Application:	**City of Dunwoody Stream Buffer Variance**
Property Location:	**4396 Old Georgetown Trail (LL 346)** **Dunwoody, Georgia 30338**
Owner/Petitioner:	**Dick Slack & Cherie Porter**
Request:	**City stream buffer variance to construct a deck**

AS-BUILT HOUSE LOCATION PLAN FOR:
DICKIE L. SLACK &
LADONNA C. PORTER
LAND LOT 346- 18th DISTRICT
DEKALB COUNTY, GEORGIA
BEING LOT 7, EMERALD PARK AT GEORGETOWN S/D

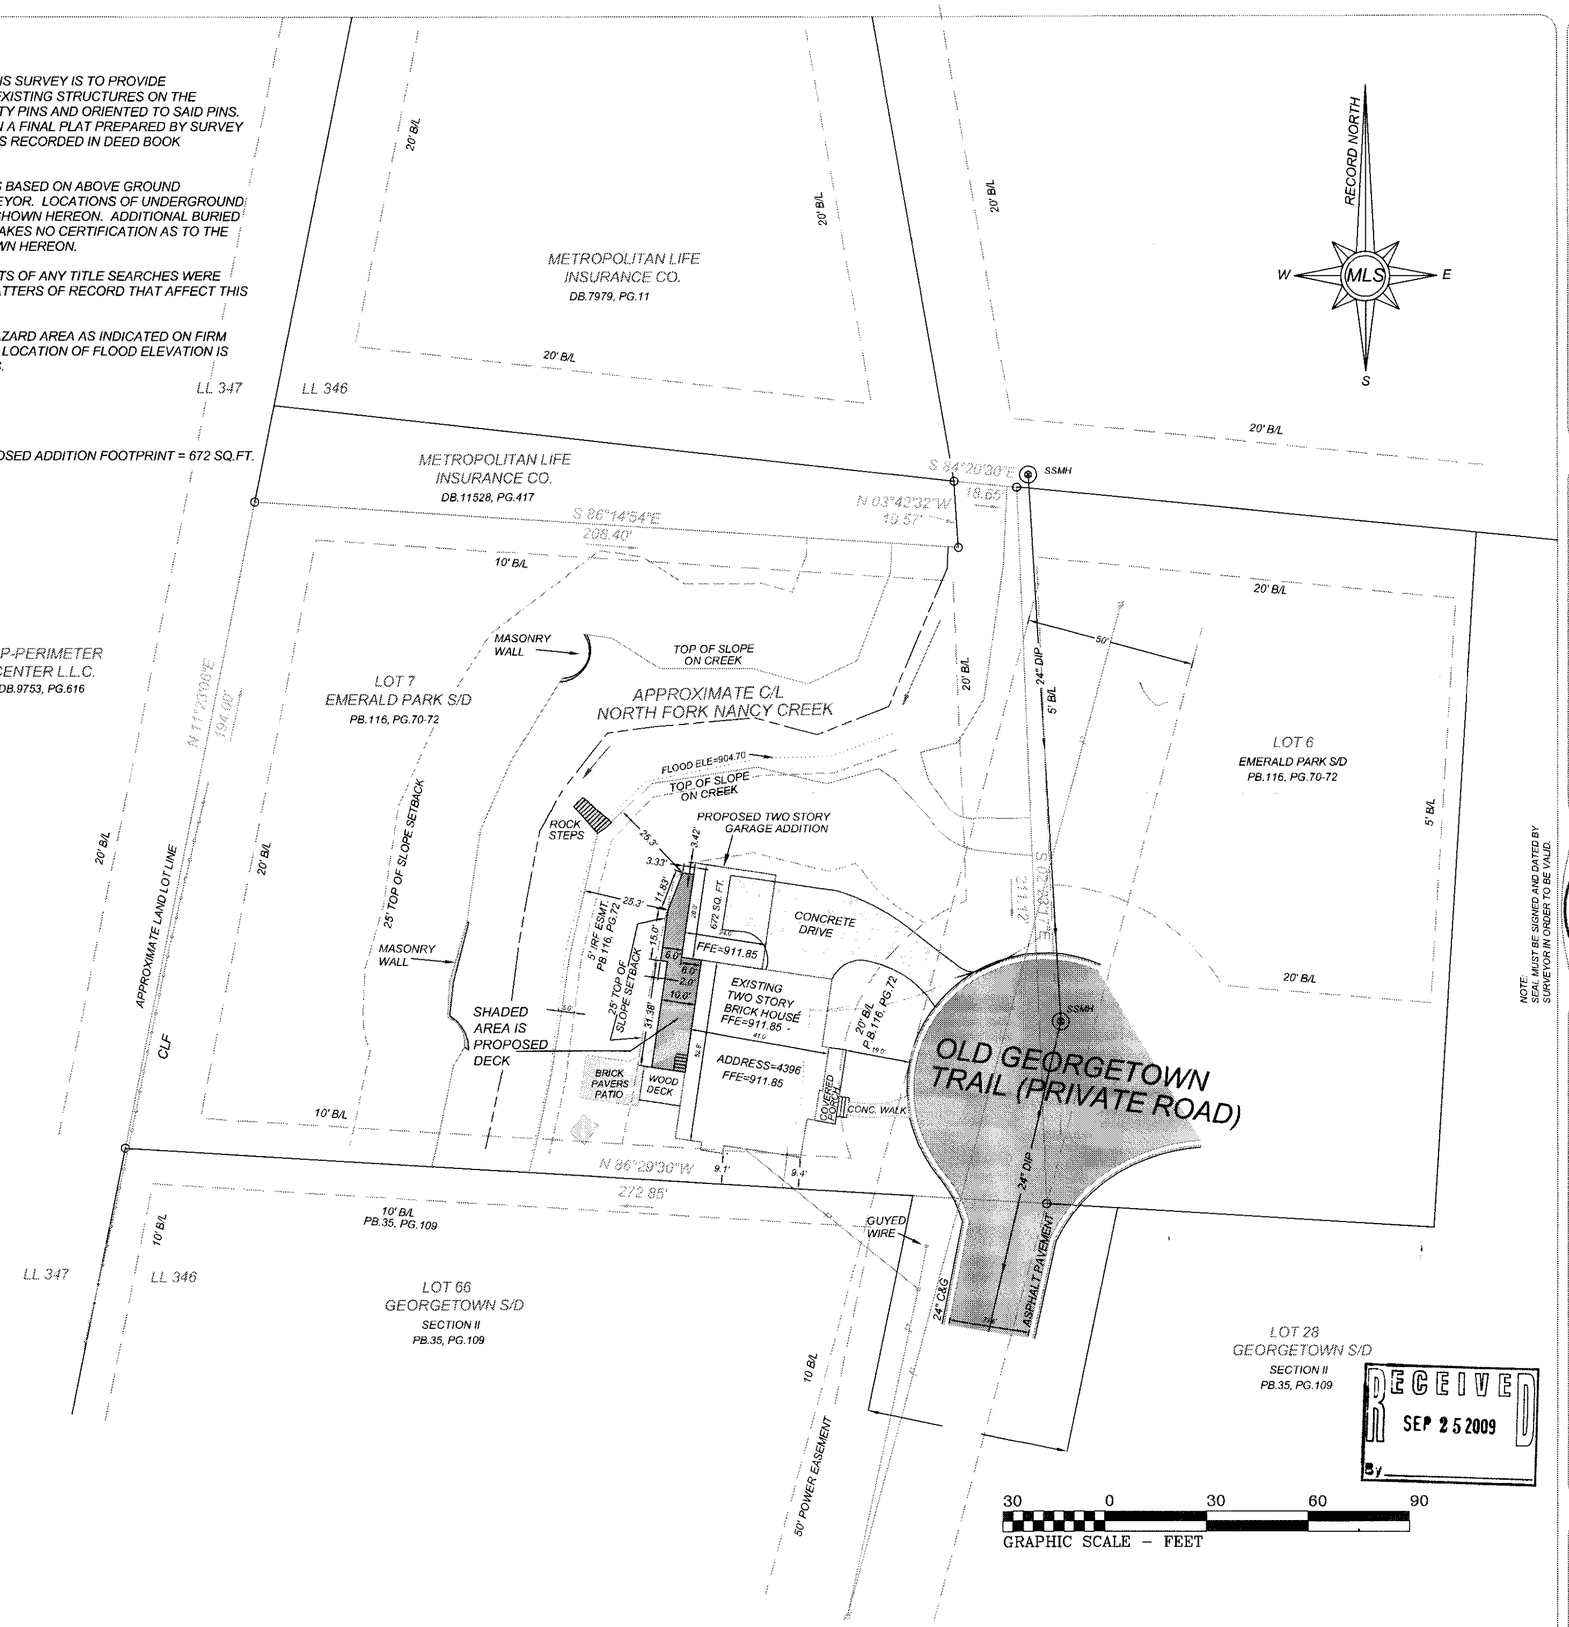
The proposed deck construction is indicated to comprise 460 square feet of impervious surface inside the stream buffer upon completion of the project. The entirety of the home and garage, save for 400+/- square feet of the front of the structure, now lies inside the City of Dunwoody 75-foot stream buffer. The deck is indicated to be attached to the rear of the home.

In the letter of justification & intent from the owner (attached to this document), special provisions for storm water run-off mitigation have been proposed for implementation around the deck area. These measures are proposed to compensate for the addition of impervious surfaces inside the City stream buffer, and appear to not only be adequate, but compliant with the Georgia Stormwater Management Manual.

- Application
- Letter of justification & intent dated September 10 and received September 11
- Site plan, entitled 'As-Built House Location Plan for Dickie L. Slack & Ladonna C. Porter', dated 09/16/09 and stamped received by the Community Development Department 09/25/09
